DCN No. E990440-00-D

DOCUMENT CHANGE NOTICE (DCN)

DOCUMENT No. (DOC-REV-GP. ID)	TITLE	NEW REV.
D990479-A-D	PAM Bracket, Aluminum	B

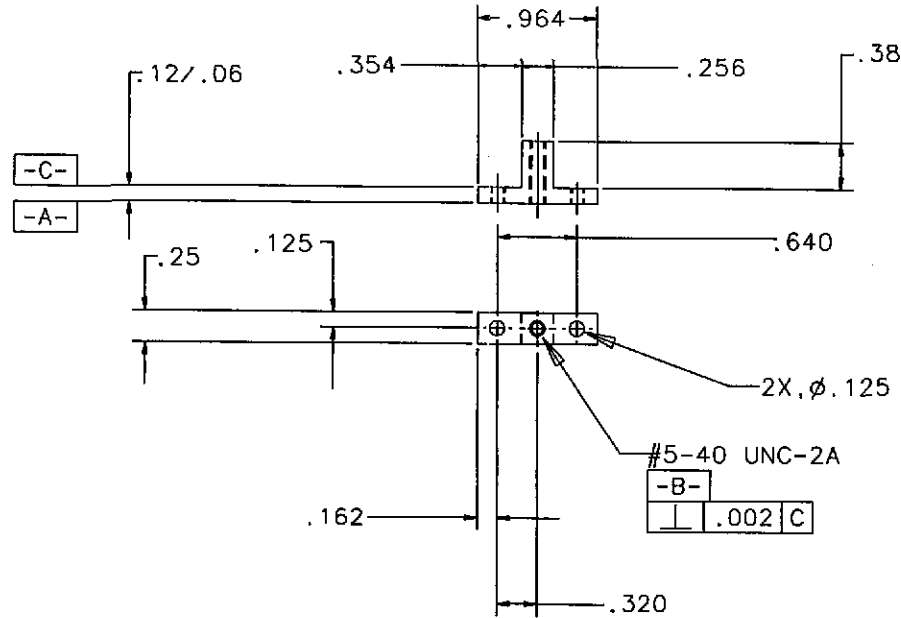
CHANGE DESCRIPTION (FROM/TO): Add geometric dimensioning and tolerancing. Add note #3 about machining fluids.

REASON FOR CHANGE: update for remachining. Schober's delivered parts with #4-40 thread instead of required #5-40.

- NOTES: (UNLESS OTHERWISE SPECIFIED)
 1. REMOVE ALL SHARP EDGES.
 2. MATERIAL: 6061-T6 ALUMINUM.
 3. CUTTING FLUIDS TO BE WATER SOLUABLE AND FREE OF SULFUR, CHLORINE AND SILICONE.
